HISTORIC AND DESIGN REVIEW COMMISSION

April 06, 2022

HDRC CASE NO: 2022-174
ADDRESS: 634 CEDAR ST
LEGAL DESCRIPTION: NCB 2912 BLK 1 LOT S 10 FT OF 8 & N 40 FT OF 9
ZONING: RM-4, H
CITY COUNCIL DIST.: 1
DISTRICT: King William Historic District
APPLICANT: Kristin Hefty/Dado Group
OWNER: Alejandro Garcia/GARCIA ALEJANDRO A
TYPE OF WORK: Garage modifications, repair foundation, exterior modifications, roof repair
APPLICATION RECEIVED: March 17, 2022
60-DAY REVIEW: Not applicable due to City Council Emergency Orders
CASE MANAGER: Claudia Espinosa

4 NEW GARAGE FLOOR PLAN
SCALE : 1/4" = 1'-0"

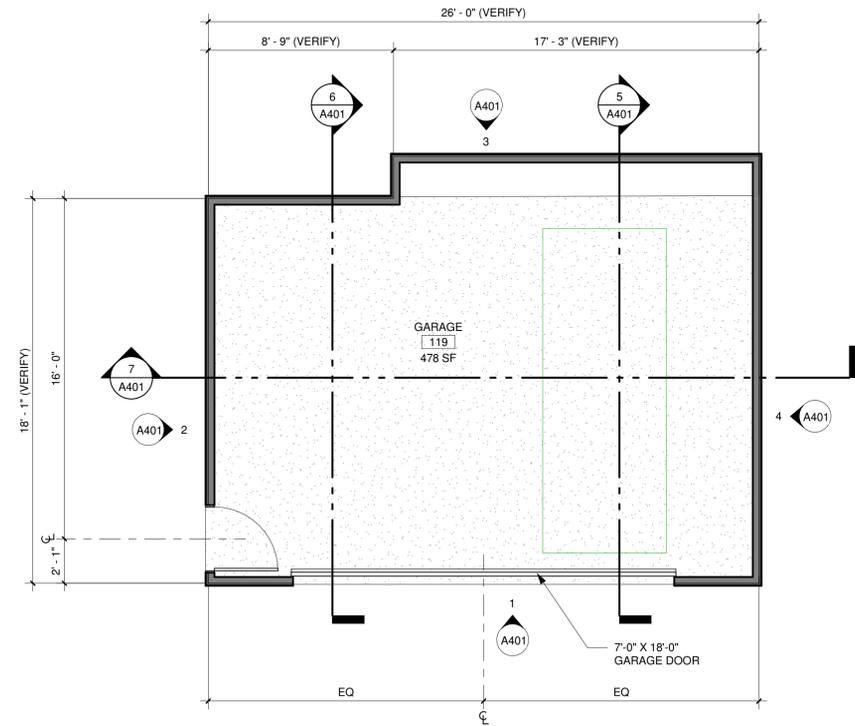
- d. PEDESTRIAN DOOR INSTALLATION – The applicant has proposed to install a pedestrian door on the west elevation of the garage. Generally staff finds this modification to be minor and on a façade that is not readily visible from the right of way. Staff finds this to be appropriate.

**GARAGE
EXTERIOR
ELEVATIONS /
SECTIONS
A401**

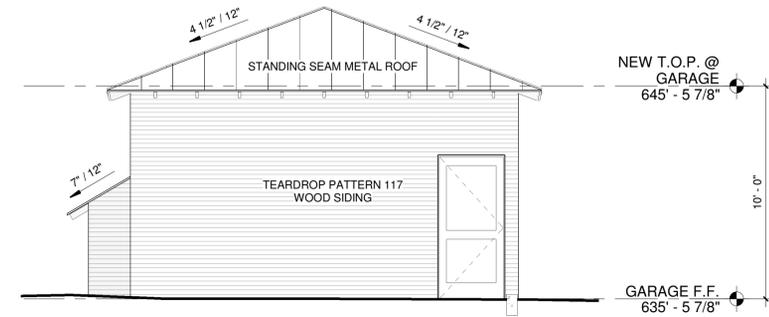
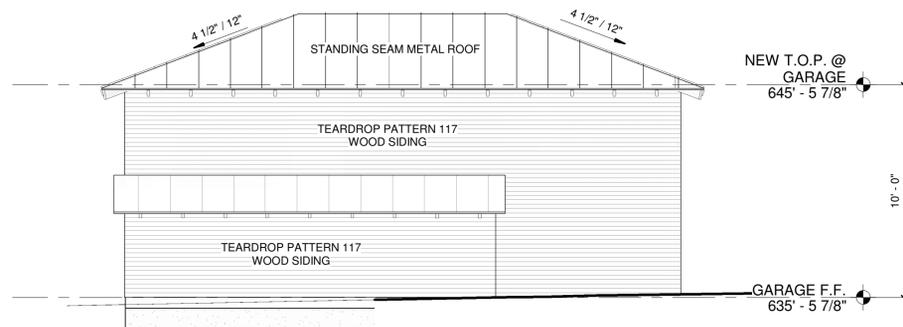
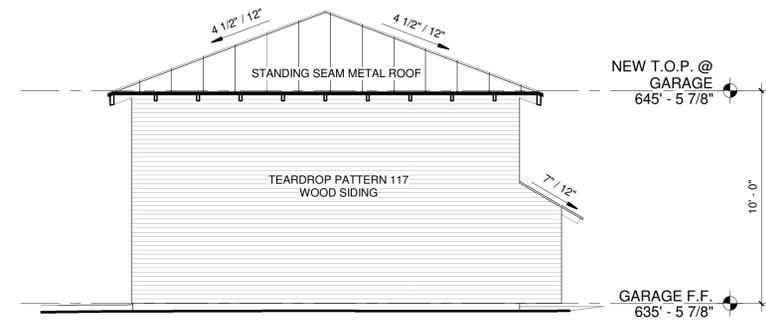
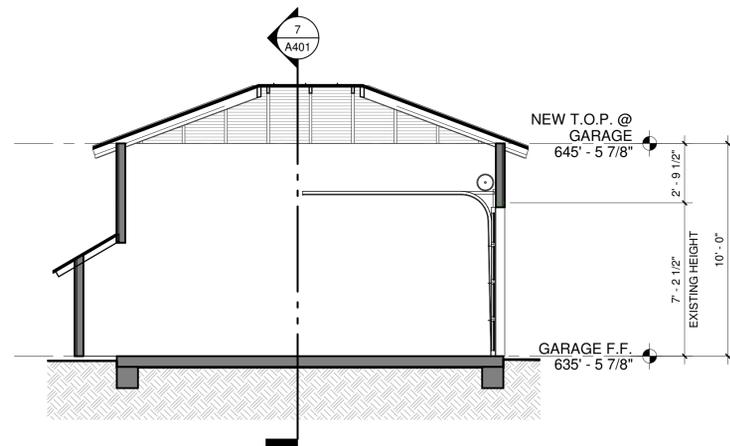
- b. FOUNDATION REPAIR – The applicant has proposed foundation repair. Staff finds the proposed scope of work to be appropriate.
- c. GARAGE DOOR REPLACEMENT—The applicant has proposed to remove the existing, sliding garage doors and install a centered, overhead garage door. Generally, staff finds the modification replacement to be appropriate; however, staff finds that the applicant should install two separate doors with sizes and profiles to be consistent with those found historically within the district and that doors appear to be wood.

- e. HEIGHT INCREASE – The applicant has proposed to increase the top plate height of the rear accessory structure by approximately 2'-10" for a total new height of approximately 14' – 0". Generally, staff finds the increase in height to be appropriate as this will not impact the structure's appearance in a significant way.

- f. SIDING REPLACEMENT – The applicant has proposed to replace the existing, board and batten siding with profile 117 siding. The Guidelines note that when new materials are needed, they should match the existing in material, color, durability and texture. A change in siding profile is not consistent with the Guidelines.

1. Staff recommends approval of item #1 based on finding c, foundation repair as submitted.
2. Staff recommends approval of item #2, the installation of a new garage door in a modified location and profile. Staff recommends the garage doors be a similarly styled wood doors be installed to match those found historically in the district in profile.
3. Staff recommends approval of item #3, the installation of a pedestrian door on the side façade.
4. Staff recommends approval of item #4, the increase of the top plate height based on finding e.
5. Staff does not recommend approval of item #5, siding profile modifications and replacement based on finding f.
6. Staff recommends approval for item #6, roof replacement based on finding g with the following stipulations:
